WELL LOCATION AND ACREAGE DEDICATION PLAT

## PECOS DISTRICT DRILLING CONDITIONS OF APPROVAL

<b>OPERATOR'S NAME:</b>	<b>APACHE CORPORATION</b>
<b>LEASE NO.:</b>	<b>NMNM0039880</b>
<b>WELL NAME &amp; NO.:</b>	<b>GHOST RIDER 22 15 FEDERAL COM 31H</b>
<b>SURFACE HOLE FOOTAGE:</b>	<b>2272'S &amp; 540'E</b>
<b>BOTTOM HOLE FOOTAGE:</b>	<b>50'S &amp; 743'E</b>
<b>LOCATION:</b>	<b>Section 15, T.24 S., R.32 E., NMP</b>
<b>COUNTY:</b>	<b>Lea County, New Mexico</b>

# Application Data Report

13-5/8" 3M PSI BOP (to be tested as a 2M)  
(Test annular to 50% WP)

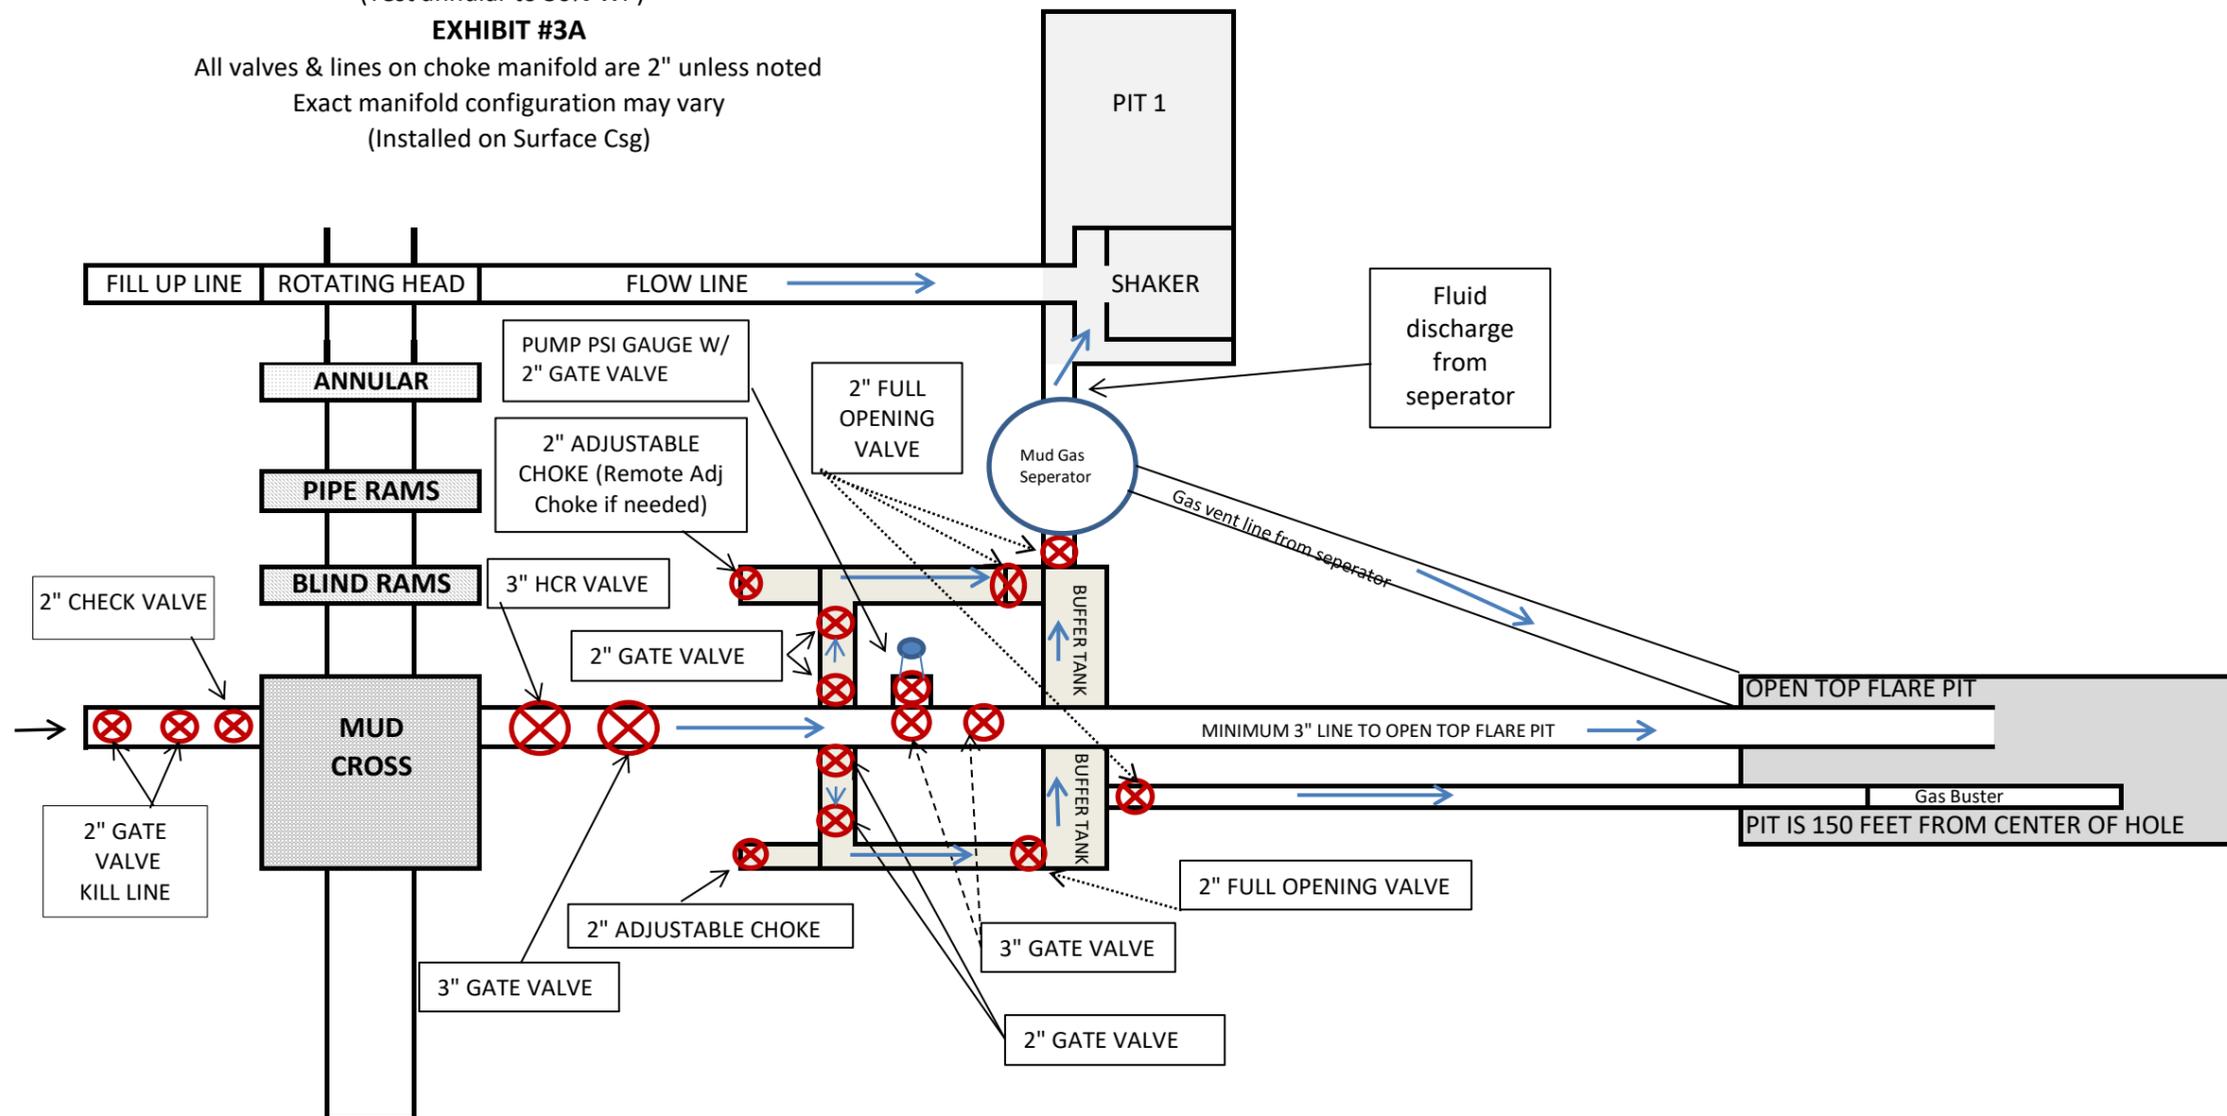
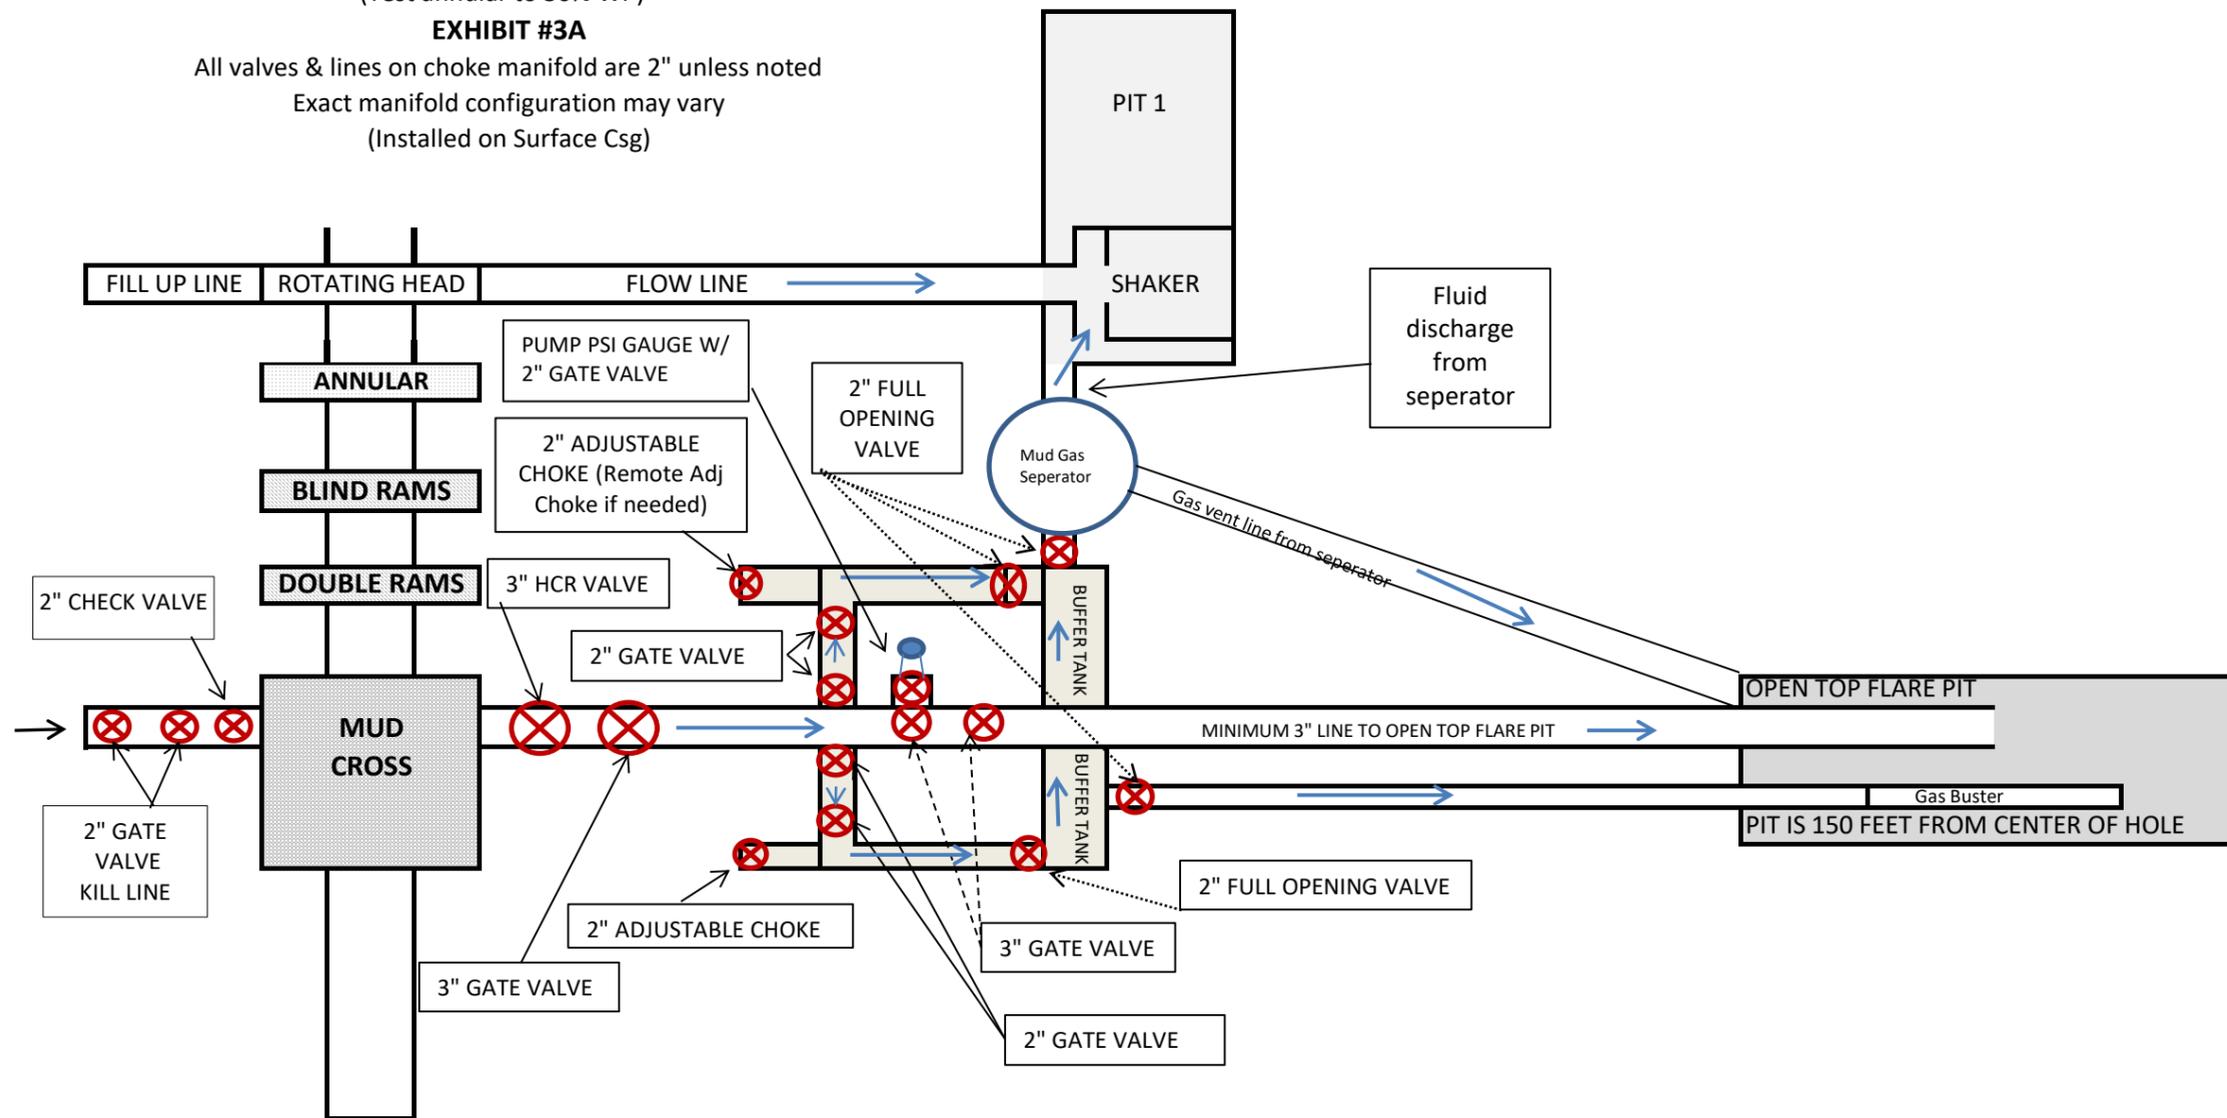
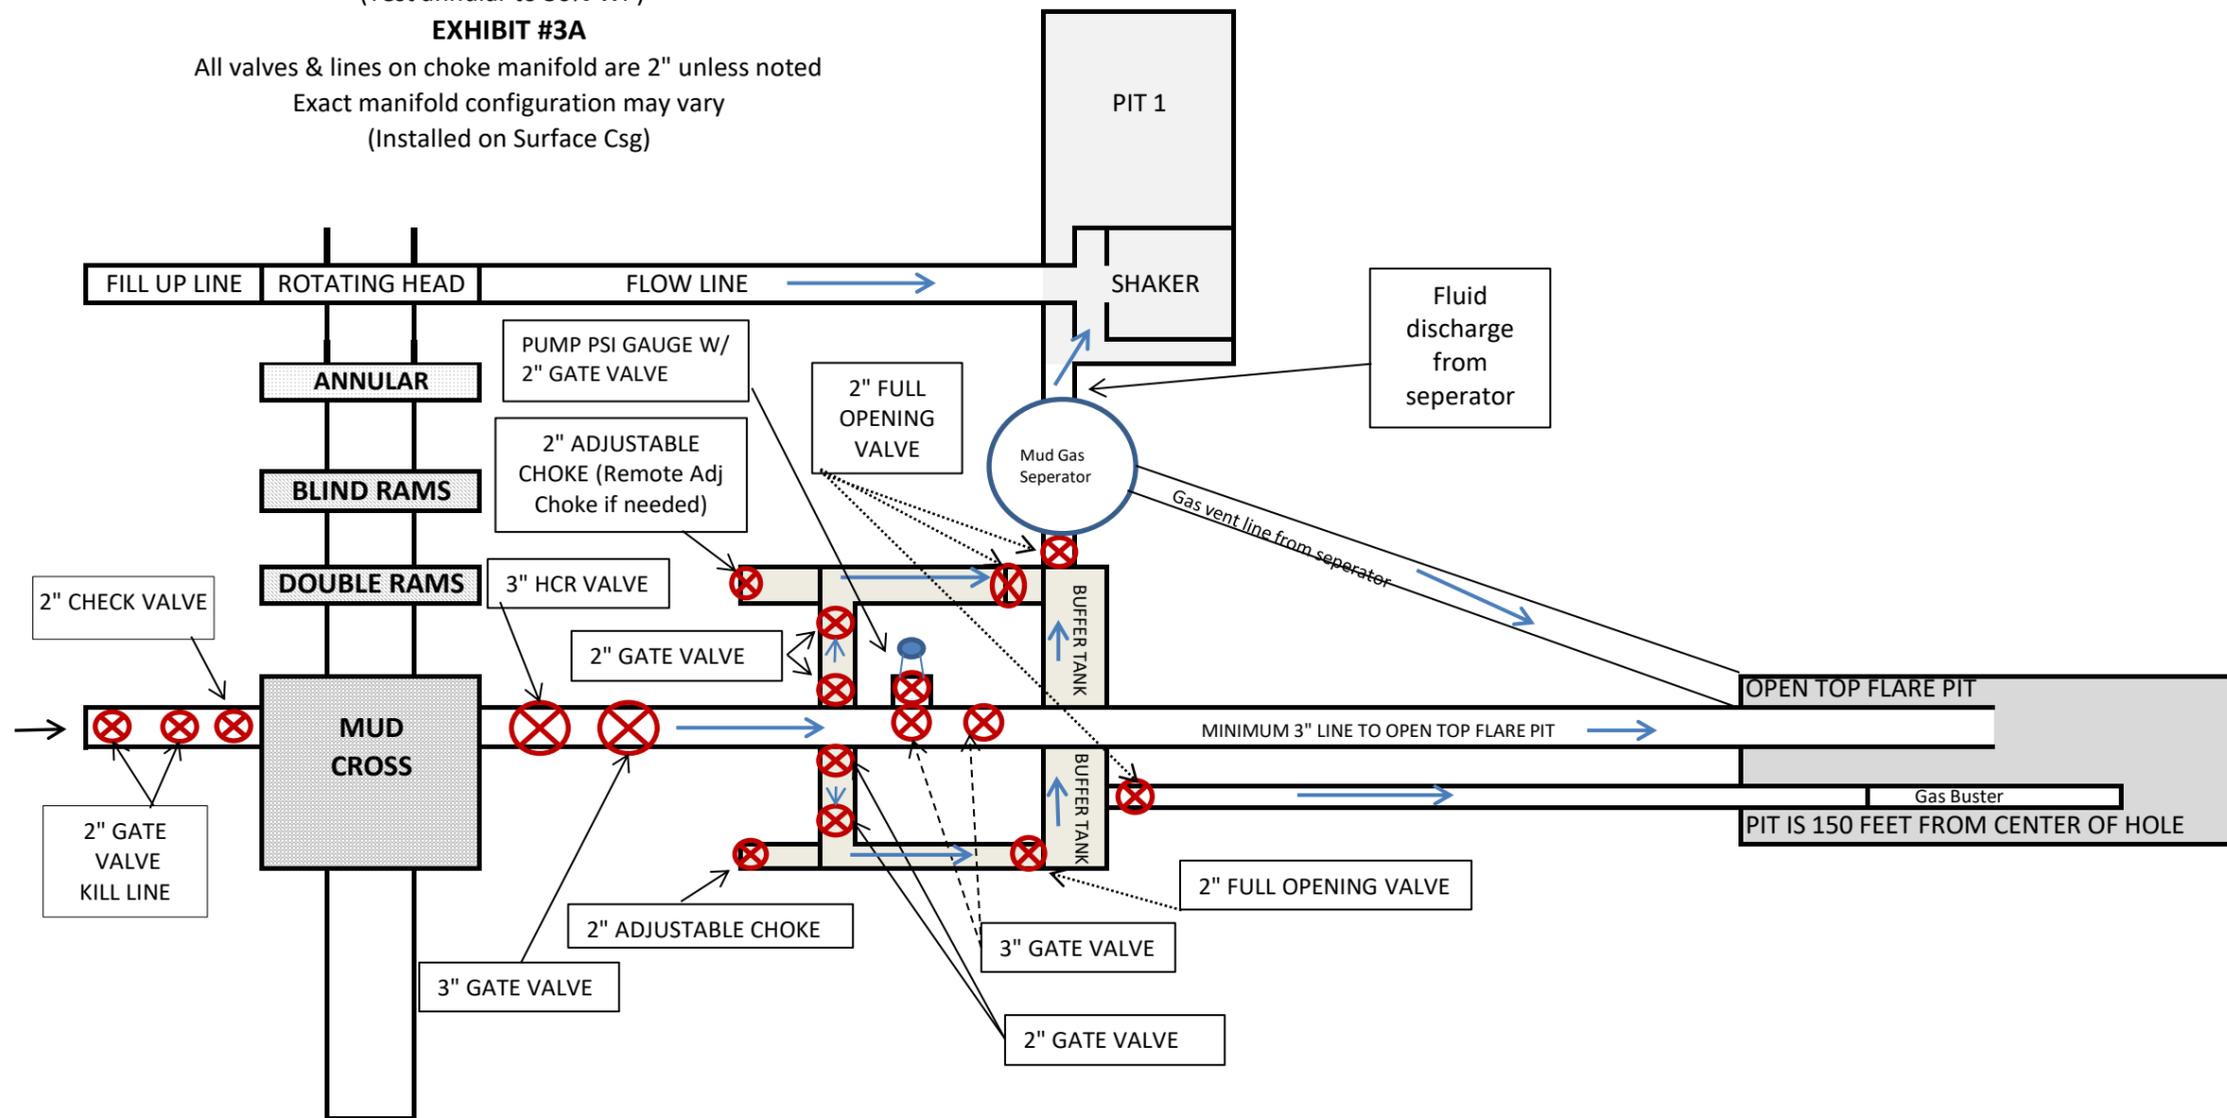
1. Variance approved to use flex line from BOP to choke manifold. Manufacturer's specification to be readily available. No external damage to flex line. Flex line to be installed as straight as possible (no hard bends).'
- 2.

- a. Minimum working pressure of the blowout preventer (BOP) and related equipment (BOPE) required for drilling below the surface casing shoe shall be **2000 (2M)** psi.
- b. Minimum working pressure of the blowout preventer (BOP) and related equipment (BOPE) required for drilling below the intermediate casing shoe shall be **3000 (3M)** psi.

1. Operator has proposed a multi-bowl wellhead assembly. This assembly will only be tested when installed on the surface casing. Minimum working pressure of the blowout preventer (BOP) and related equipment (BOPE) required for drilling below the surface casing shoe shall be **3000 (3M)** psi.
